Fashion Pulse Ltd

Plot: A - 109, BSCIC Industrial Area, Tongi, Gazipur- 1710

16 September 2025

2. Observation:

Observation 02: Lack of floor load management plan. (Factory Building)

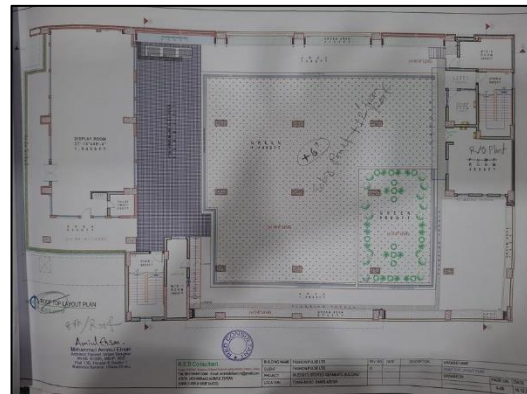
Storage on suspended ground floor

Storage area has no area/height limit

Description: At the time of inspection, floor load plan was not found posted suspended ground floor level. Also, storage area & height marking was not observed in several storage locations. The building engineer is required to post the floor load plan on all floor levels, provide storage area & height marking, and maintain floor loading accordingly.

2.		Carry out remedial work if required.	within 6 months
3.	Lack of floor load management plan. (Factory Building)	The building engineer is required to post the floor load plan on all floor levels, provide storage area & height marking, and maintain floor loading accordingly.	within 6 weeks

Factory Building

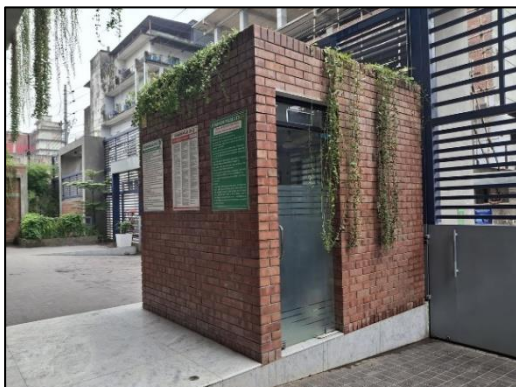
Description: At the time of inspection, some minor discrepancies were observed between floor layout and drawings for factory building. Rooftop gardening soil-built ups were not properly mentioned in the drawings, solar panel on 9th floor not mentioned in the drawing. Also, structural details of Security & RMS rooms were not available on site. The building engineer is required to survey the structure and prepare accurate as-built drawings.

4.	Mismatch in as-built drawing for Factory Building	The building engineer is required to survey the structure and prepare accurate as-built drawings.	within 6 weeks
